*Arborist Report for Palm Villas Saratoga Project:  
January 29, 2016*

## ARBORIST REPORT

### Palm Villas, Saratoga (Lots 1 & 2)

**Arborist Report #3**  
**Palm Villas, Saratoga – review of revised plans relative to existing tree impacts**

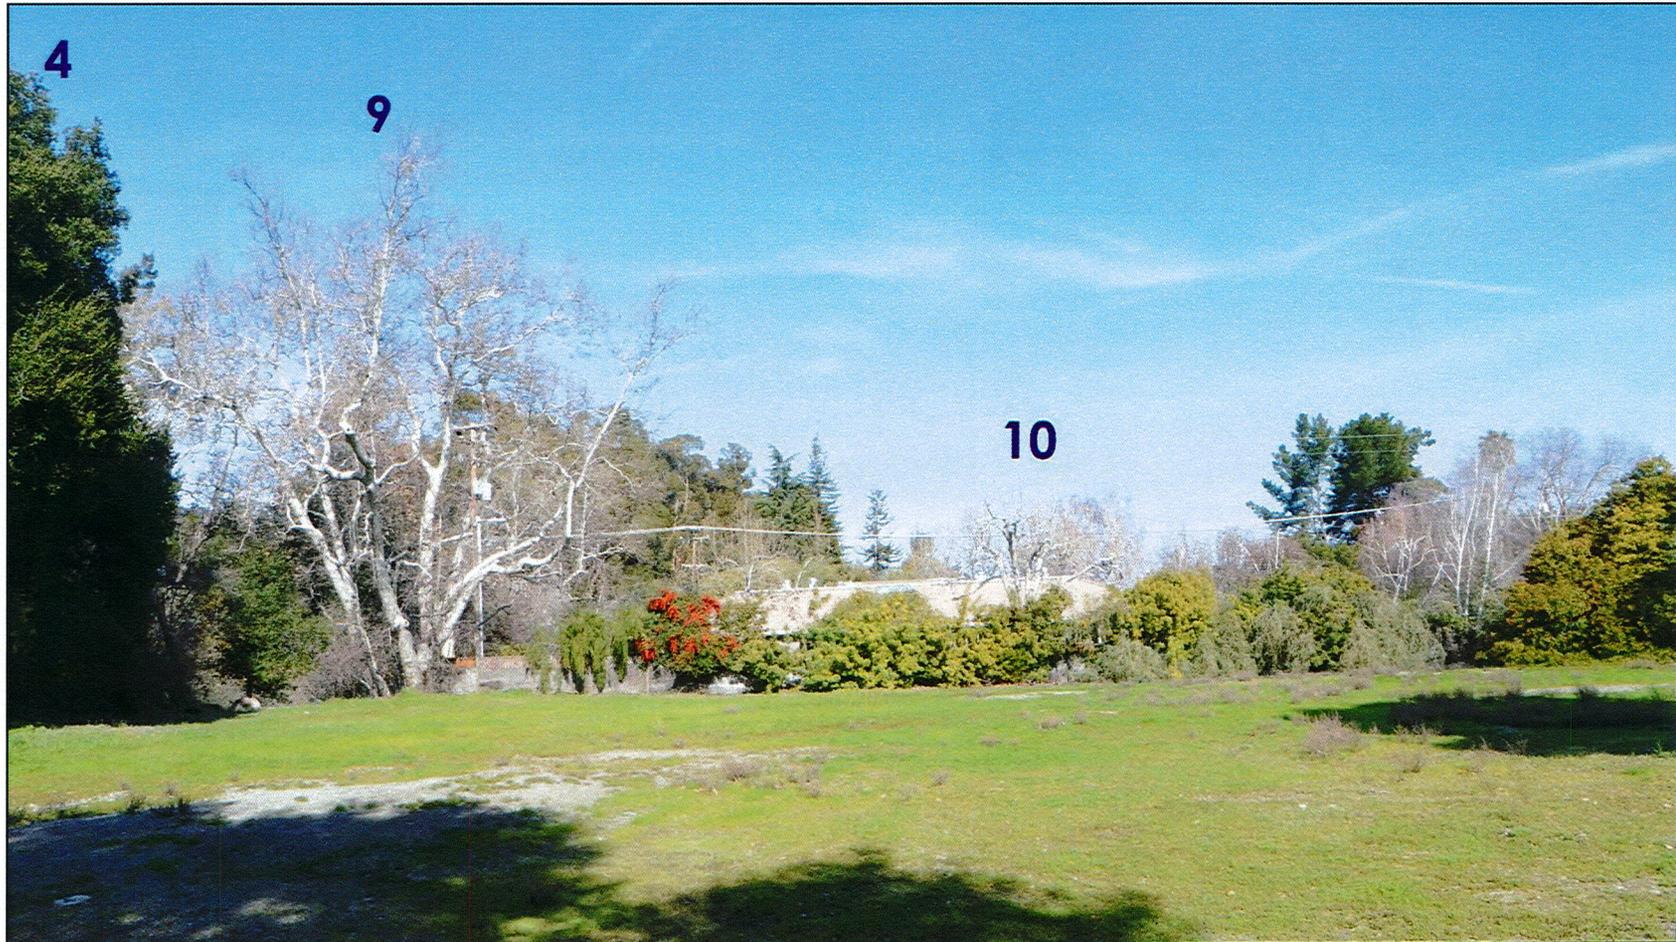
**Coast live oak #3** and the problem with the decay in one of its two trunks, the trunk leaning over the project site. The left photo shows the decayed area circled. The right photo shows a close-up of the decay. There is a lot of internal decay here, because there is a bird nest inside. The weight of the canopy is above this decayed portion.

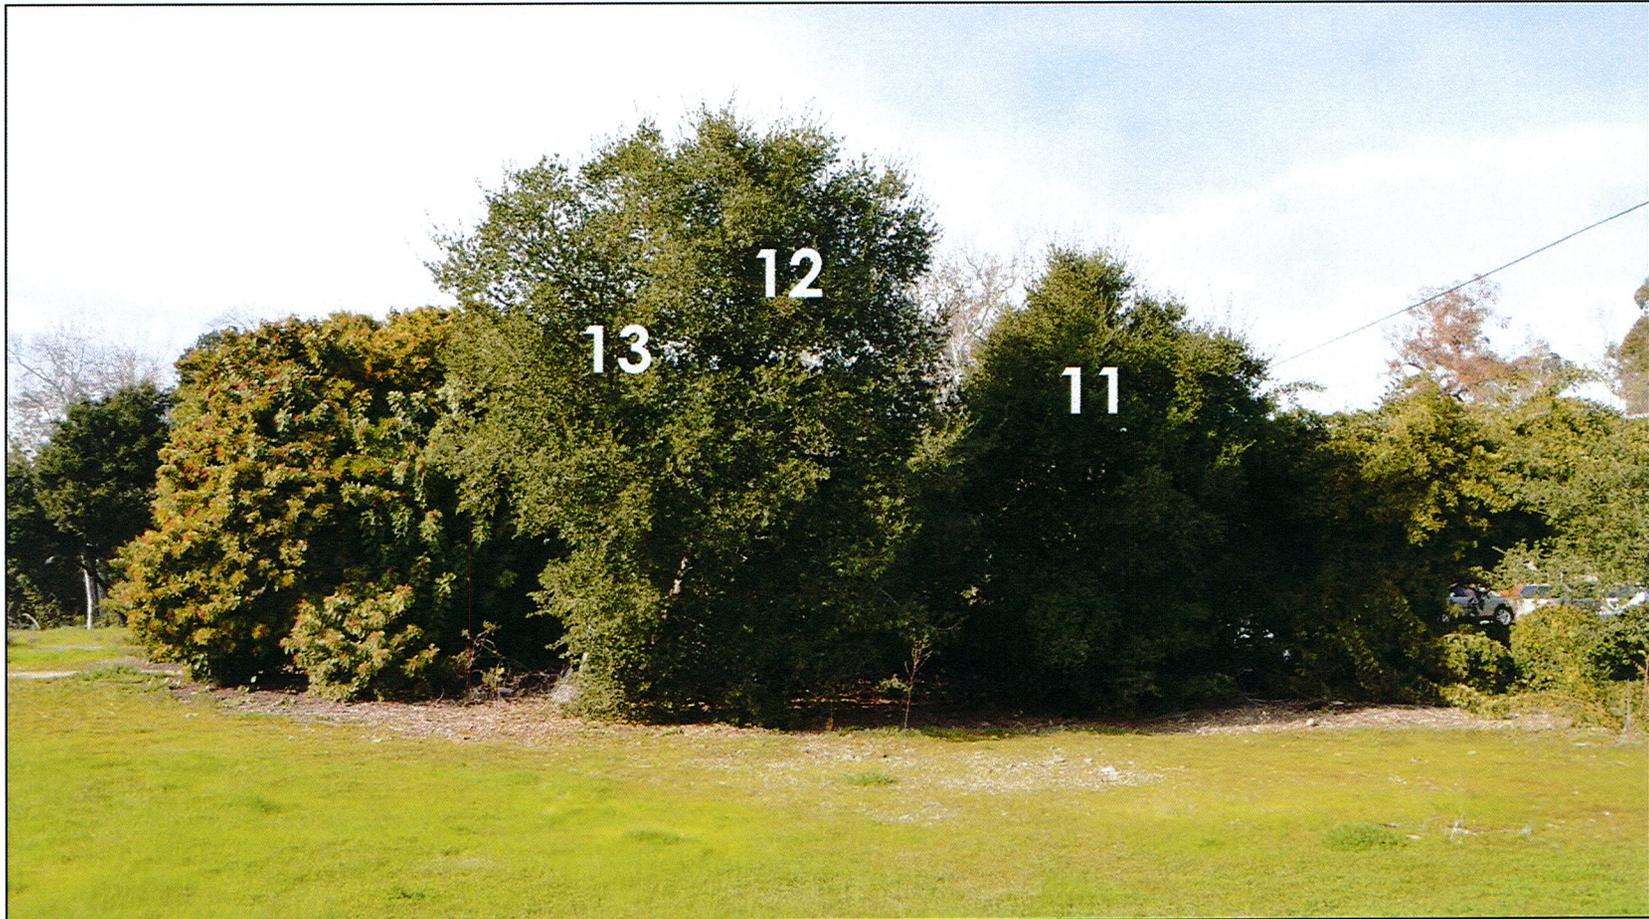
North perimeter of the site, Lot 1. Left to right: the edge of large **coast live oak #4**, **California sycamore #9** and **London plane #10**.

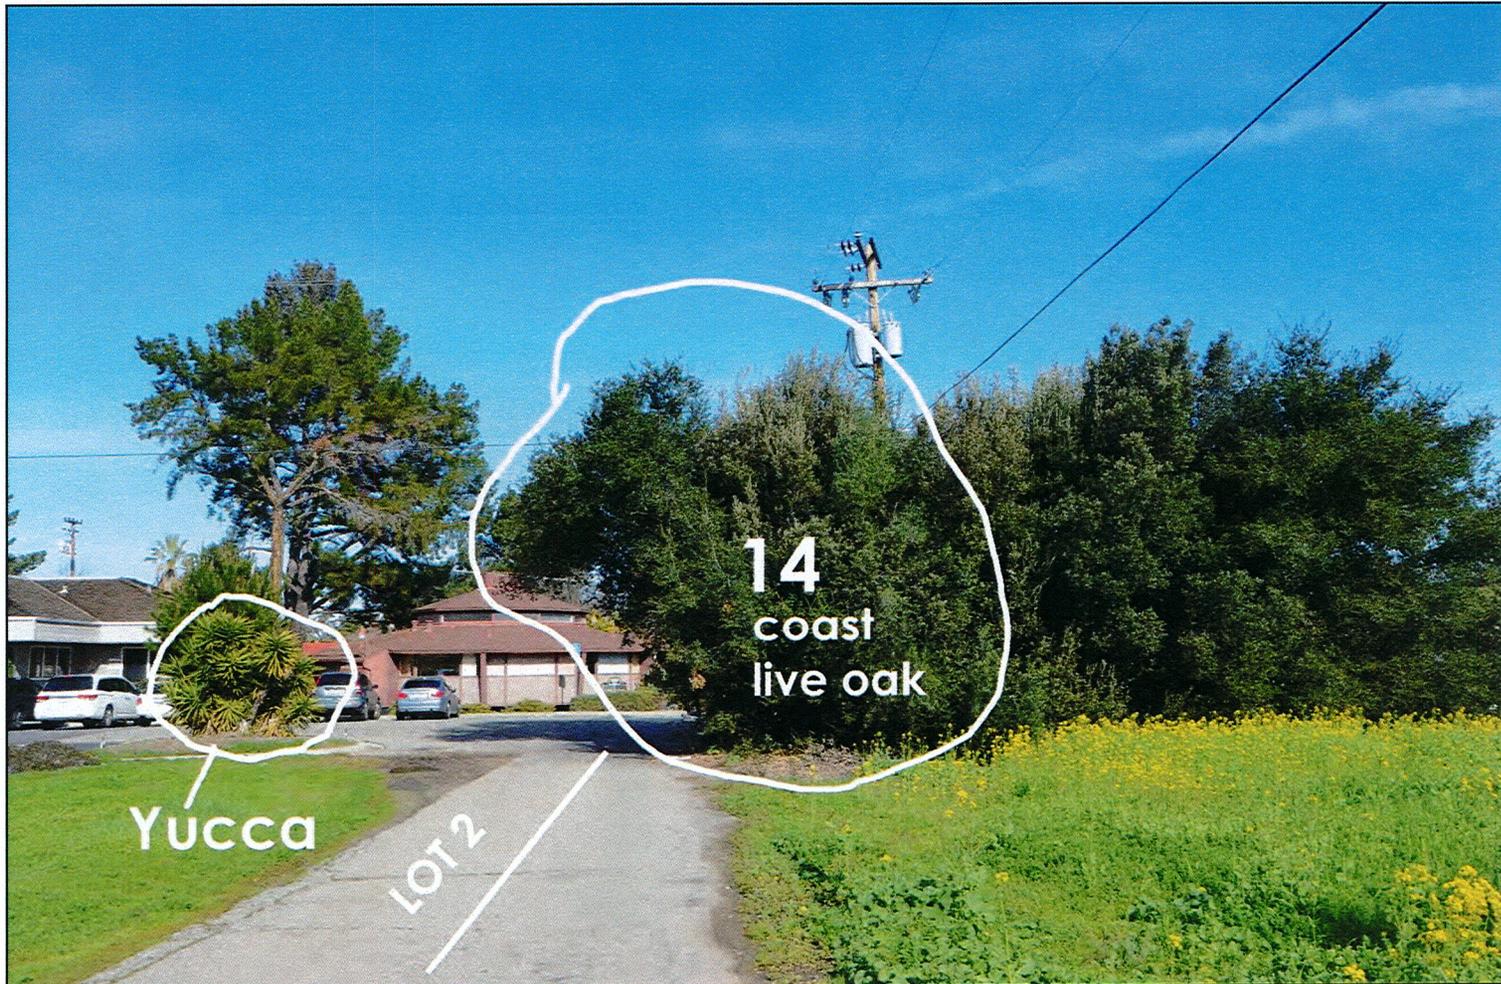
The west perimeter of Lot #2, viewed from the west. **Coast live oaks #11, 12 and 13.** All three of these trees will be removed because they will be within the extension of Saratoga Creek Drive.
